STATE OF WASHINGTON
DEPARTMENT OF ECOLOGY

**Re: Opinion Pursuant to WAC 173-340-515(5) on Proposed Remedial Action for the
Following Hazardous Waste Site:**

- **Name:** Main Street Former Mobil Station
- **Address:** 10328 Main St, Bellevue, WA
- **Facility/Site No.:** 10321
- **VCP No.:** NW2772
- **Cleanup Site ID No.:** 12187

3B

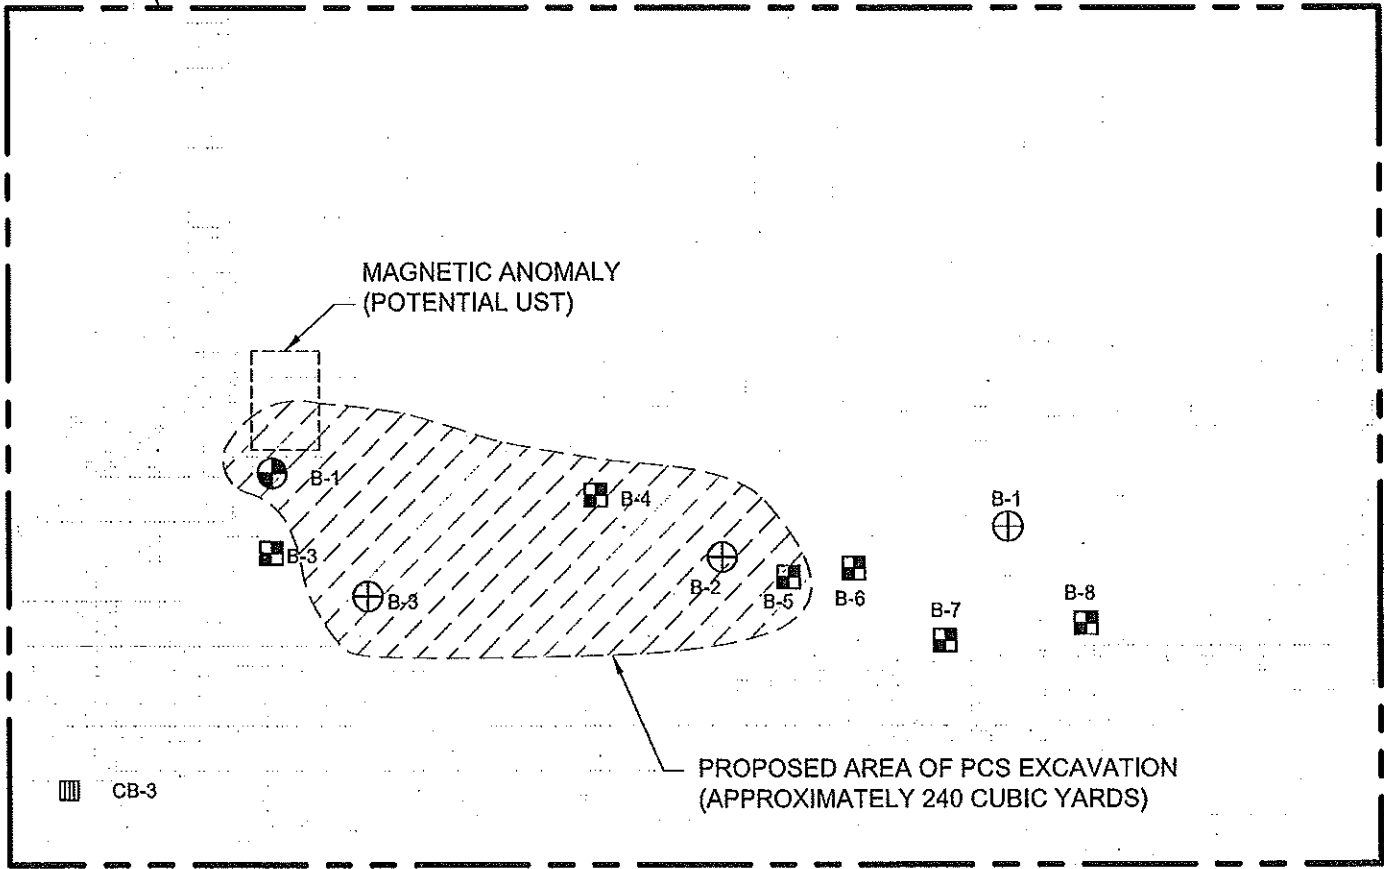
- The areal extent of ground water contamination has not been defined surrounding B-3, where the only ground water sample was collected and contained concentrations of TPHg above MTCA Method A cleanup level at 2,100 micrograms per liter (µg/l). No data is presented for the one monitoring well (MW-1) that was installed in 2012 near B-3.

Groundwater data for monitoring wells screened at or close to the water table are necessary to determine the nature and extent of the plume near B-3. Once additional data is collected, the vertical and lateral boundaries of the contaminant plumes as far as they are known need to be defined in writing, and supported with illustrations and comprehensive data tables.

- Section 2.4.2 of the RI states that a groundwater sample from the "northeast corner of the property" contained PCE, and that an active dry cleaner was located "one block to the north". The RI figures do not show a boring in the northeast corner of the Property, and the text does not provide the name or depth of the sample collected. Provide text that indicates the boring name and depth of samples collected and ensure that all sample locations are shown on the figures and all results presented on tables. It is not clear if the source of the PCE in groundwater is at the Parcel or is the dry cleaner north and up-gradient of the Site. PCE has been detected in monitoring wells with water levels at approximately 30 feet bgs at the adjacent former Chevron Service Station 0587. Based on PCE detections in groundwater at and immediately adjacent to this Site, additional characterization for PCE and its degradation products is required to determine the source and nature and extent of PCE in groundwater. Consideration of multiple water-bearing zones and potential on- and off-Property sources must be included in the characterization. Appropriate drilling and installation methods should be used during this assessment to prevent cross-contamination of the water-bearing zones.
